Landscape Referral Response

Application Number:	DA2023/0669
Date:	11/07/2023
Proposed Development:	Demolition work and the construction of 28 dwellings, infrastructure, roadworks, tree removal, landscaping, community title subdivision and the dedication of the creekline corridor to Council.
Responsible Officer:	Alex Keller
Land to be developed (Address):	Lot 4 DP 553816 , 16 Macpherson Street WARRIEWOOD NSW 2102

FIGURE 1: *encroachment into the 'landscape area' - typical of all proposed residential Lots*

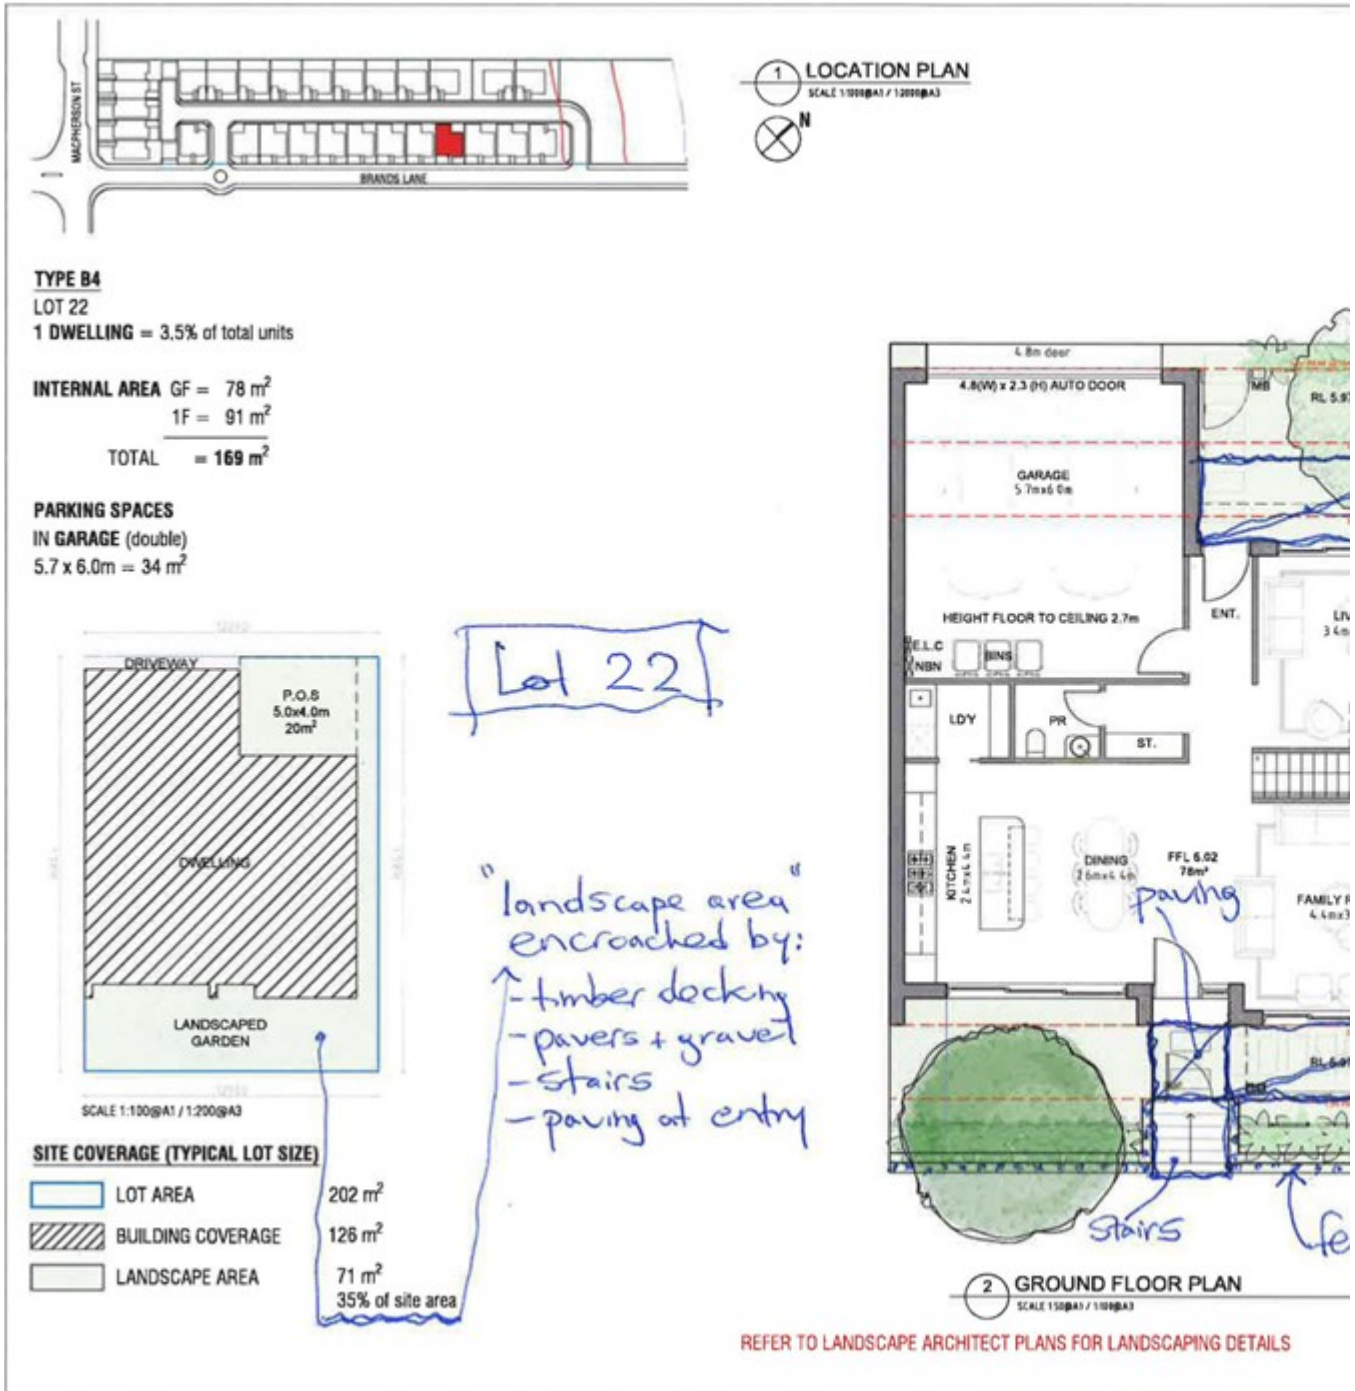
- The 'landscape area' calculations as identified in the architectural site plans are based solely of building footprint within the residential lot and include areas that are under structures such as roofs, terraces and balconies, and additionally include external stairs, dwelling entry paths as 'landscape area'

when such areas are clearly unable to support planting, such that the 'landscape area' calculations as defined in the PLEP are overstated. The Landscape Plan proposals further compromise the 'landscape area' with timber decking and areas of pavers and gravel shown on the plans within calculated 'landscape areas'. A typical analysis of this assessment is available in Figure 1.
